**SUBDIVISION, PLANNED UNIT DEVELOPMENT  
& SIDEWALK WAIVER STAFF REPORT****Date: January 8, 2008****APPLICANT NAME**

Longleaf Pines Apartments

Northeast corner of Girby Road and Lloyds Lane.

# SITE PLAN

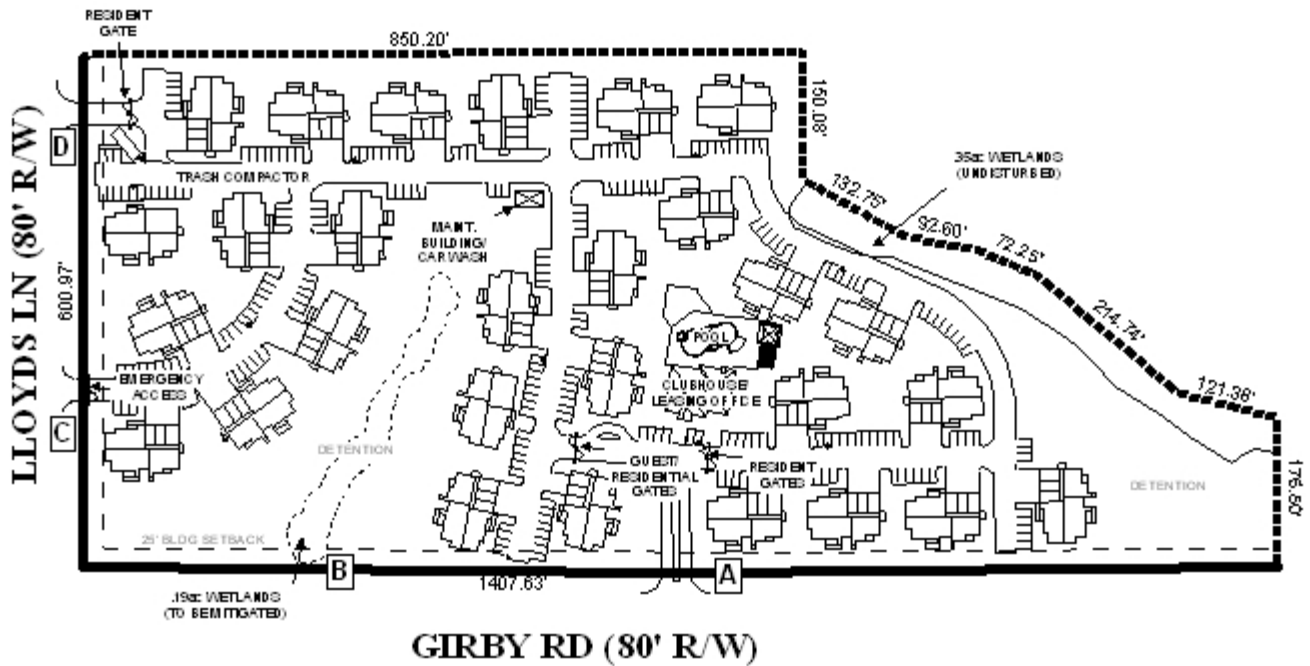
Driveway number, size, location, and design to be approved by Traffic Engineering and conform to AASHTO standards. A traffic impact study has been submitted for this development. Recommendations for the project include construction of a left turn lane for the Girby Road driveway. Changes should be made in the plans to accommodate this recommendation.

Lane which is located along the northern portion of the development is limited to residents only. The site also illustrates an emergency access approximately 200-feet from the intersection of Girby Road/Lloyds Lane. While this emergency access is required for emergency vehicle use, a note stating that this access will remain closed and only used by emergency vehicle should be placed on the Final Plat and site plan.

- 1) completion of the Subdivision process prior to application for building/Land Disturbance permits;
- 2) the placement of a note on the site plan stating that this access will remain closed and only used by emergency vehicles only;

- 3) provision of a revised PUD site plan to the Planning Section prior to signing of the Final Plat; and
- 4) full compliance with all other municipal codes and ordinances.
